SUBJECT: REMOVAL OF CYCLE-SPECIFIC PARAMETER LIMITS FROM THE TECHNICAL SPECIFICATIONS, SUSQUEHANNA STEAM ELECTRIC STATION, UNITS 1 AND 2 (MPA D021 AND D027) (PLA-3892) (TAC NOS. M85486 AND M85487)

The Commission has issued the enclosed Amendment No. 126 to Facility Operating License No. NPF-14 and Amendment No. 95 to Facility Operating License No. NPF-22 for the Susquehanna Steam Electric Station, Units 1 and 2. These amendments are in response to your letter dated December 18, 1992, as supplemented by your telecopy dated January 28, 1993 and your letters dated March 25, and May 20, 1993.

These amendments change the Technical Specifications (TSs) to remove cycle-specific parameter limits in accordance with NRC Generic Letter 88-16 and modify Section 5.3.1 in accordance with NRC Generic Letter 90-02, Supplement 1.

**Figure 3.4.1.1-1
THERMAL POWER RESTRICTIONS**

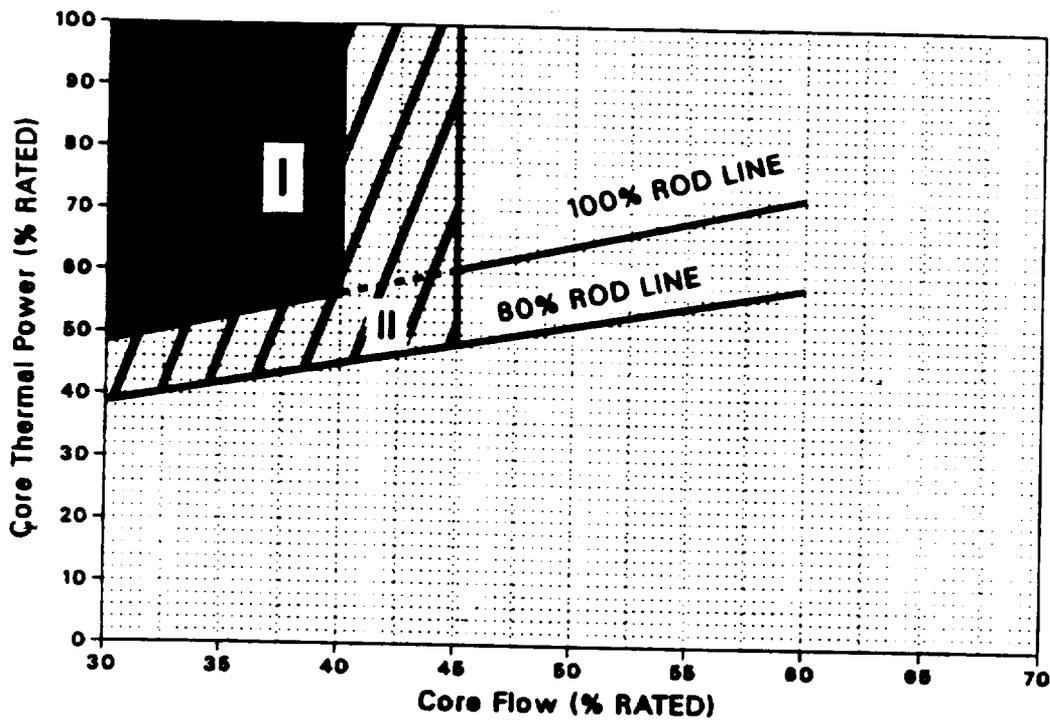
- d. For Unit 1, replace the present Figure 3.4.1.1.1-1 on "Thermal Power Restrictions" with the figure that is in the Unit 2 TSs and which was approved for Unit 2 by Amendment No. 91 issued October 28, 1992.

In the application of December 18, 1992, the licensee proposed to relocate Figure 3.4.1.1.1-1, "Thermal Power Restrictions," to the COLR and to revise and repaginate Sections 3.4.1.1.1 and 3.4.1.1.2 on Two-Loop and Single-Loop operation to reflect the proposed deletion of this figure from the TSs.
